WATTS BAR NUCLEAR PLANT UNITS 1 AND 2 - SOLID-STATE PROTECTION SYSTEM TEST PROCEDURES - WBRD-50-390/82-91, WBRD-50-391/82-87 - SECOND INTERIM REPORT

ENCLOSURE
WATTS BAR NUCLEAR PLANT UNITS 1 AND 2
SOLID-STATE PROTECTION SYSTEM TEST PROCEDURES
10 CFR 50.55(e)
NCR WBN NEB 8217
WBRD-50-390/82-91 AND WBRD-50-391/82-87
SECOND INTERIM REPORT

**ATTACHMENT
SIMPLIFIED SKETCH OF SSPS TEST CIRCUIT
(SAFEGUARDS ACTUATION RELAY)**

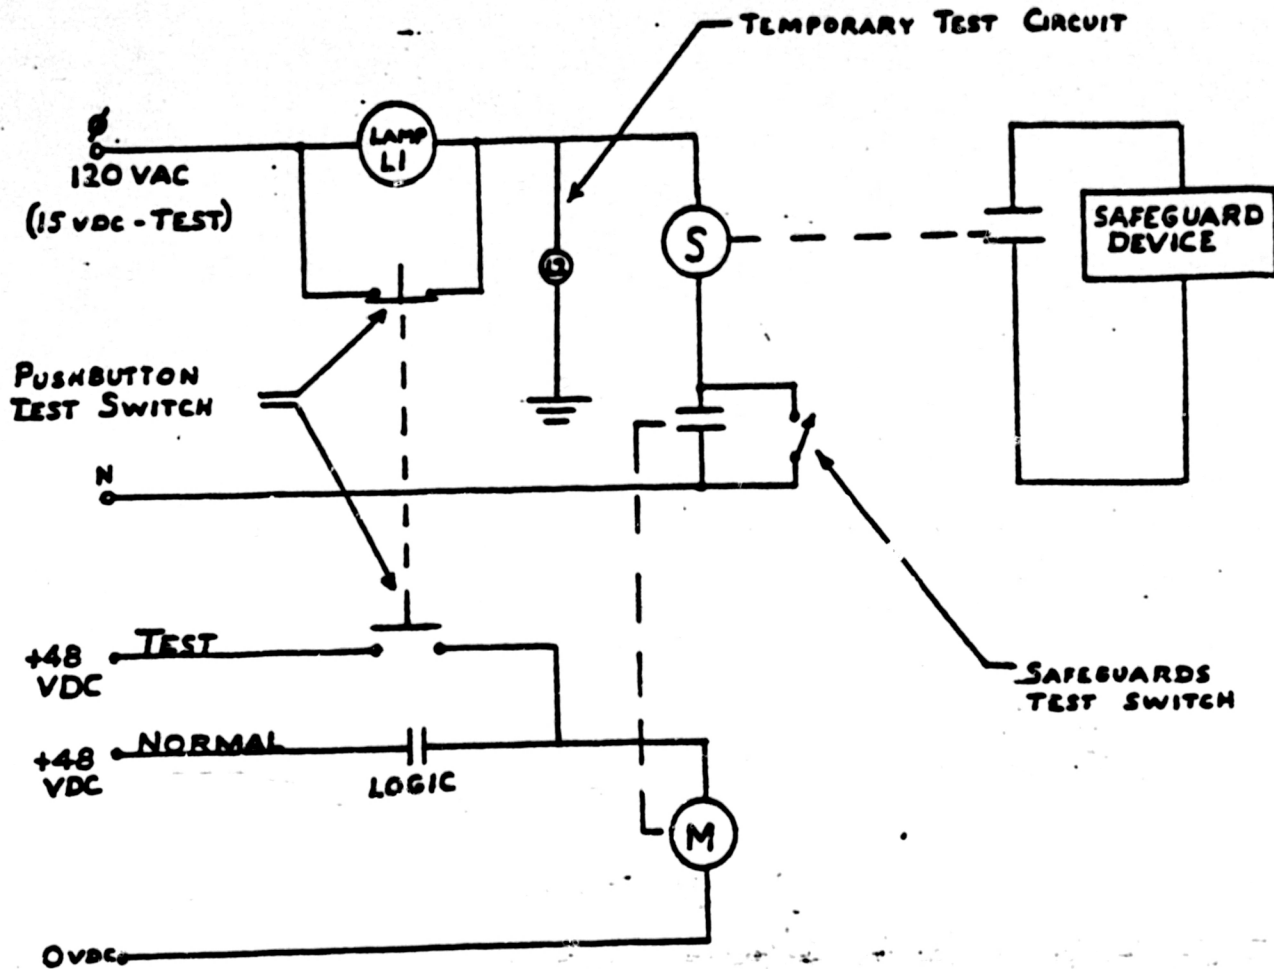
TVA has reviewed Westinghouse's proposal for a procedural change and has decided not to use it. Instead, TVA will implement its own procedural change using a test probe with an indicator lamp connected to a ground and to a point between the shunt switch and the slave relay. (See attachment)

After returning the shunt switch to its normally closed position, this additional test circuit would give one of three indications:

1. Both the probe lamp and the relay test lamp would light which would indicate failure of the shunt switch.
2. Neither lamp would light which would indicate failure of both the shunt switch and the relay test lamp.
3. The probe lamp would light while the relay test lamp would remain dark. This would indicate proper restoration of the shunt.

If the shunt has been restored, then the probe circuit would be removed and the operating voltage of 120V ac would be restored to the slave relay circuit.

Normal Operation: "Logic contacts close to pick up Master relay M.
Master relay contacts close to apply 120V ac to Slave relay S.
Slave relay contacts close to power the Safeguards device.

During Testing: Relay mode selector switch (not shown) to "Test" position switches 120V ac to 15V dc.
Pushbutton test switch picks up Master relay M and applies 15V dc to Slave relay coil thru proving lamp L.
Slave relay is not energized because of reduced voltage of 15V dc.
Test Circuit 2 indicates correct return of pushbutton.
Test Switch by Lit-Unlit status of L2. Circuit is removed before returning slave circuit to 120V ac.
